AGENDA – Engineering and Construction Committee

- III. Report of Status of Operations and Construction
- IV. **Resolution R-66-25:** A Resolution Awarding a Contract for the Construction of the West Transmission Main along Book Road From 75th Street to the ComEd R.O.W. (Contract TW-6/25 Section 1 (Book Road))

DUPAGE WATER COMMISSION
WATERLINK EXTENSION
CONTRACT TW-6/25 SECTION 1 WEST TRANSMISSION MAIN

4 CP-4 - FOREIGN PIPELINE CROSSING TEST STATION
SCALE: N.T.S.

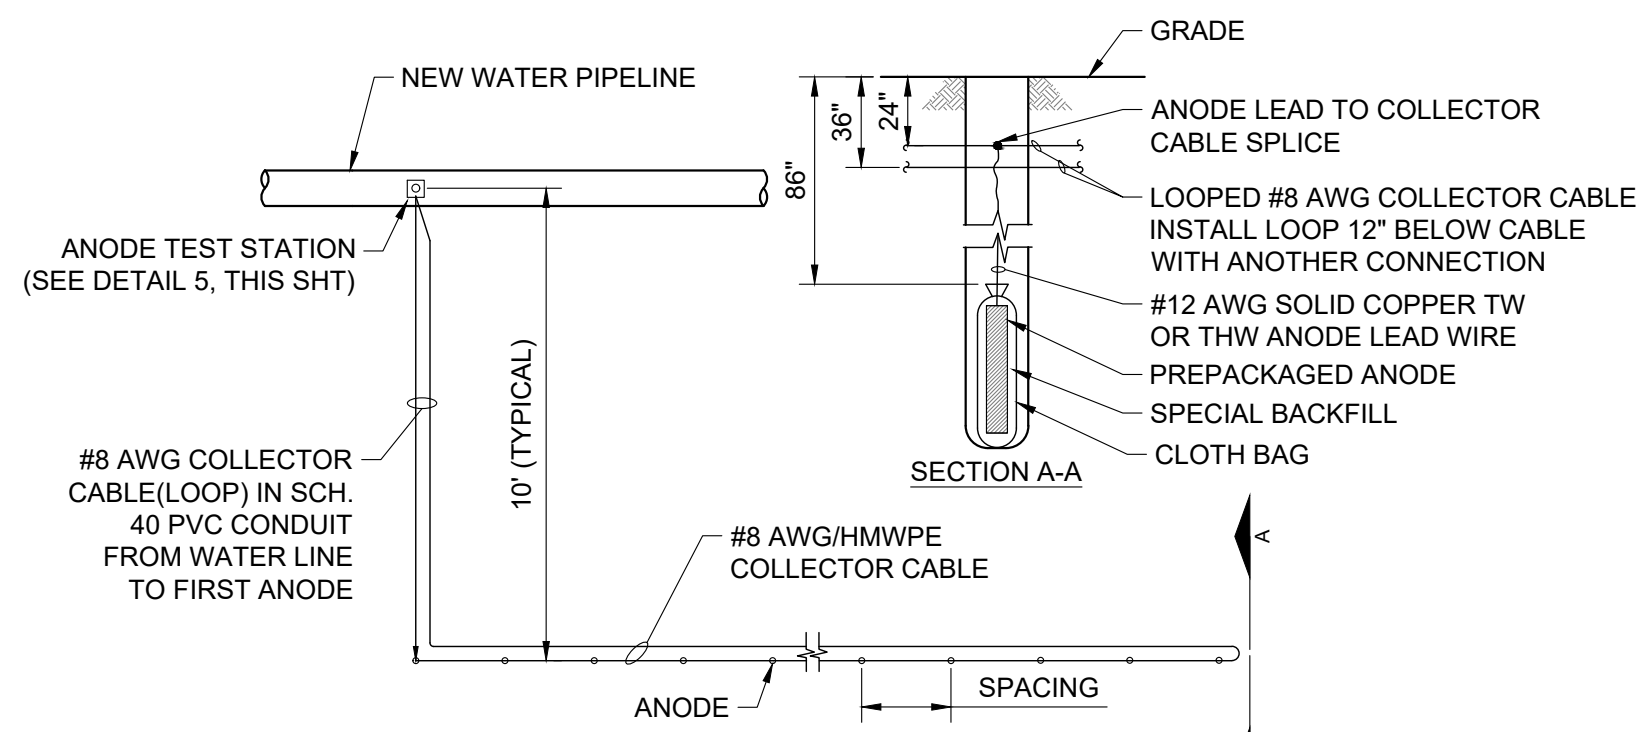
- V. Remove Sheet 183 of 199 (Drawing CP-501) in its entirety and replace with the attached revised Sheet 183 of 199.
- W. Remove Sheet 184 of 199 (Drawing CP-502) in its entirety and replace with the attached revised Sheet 184 of 199.
- X. Remove Sheet 185 of 199 (Drawing CP-503) in its entirety and replace with the attached revised Sheet 185 of 199.
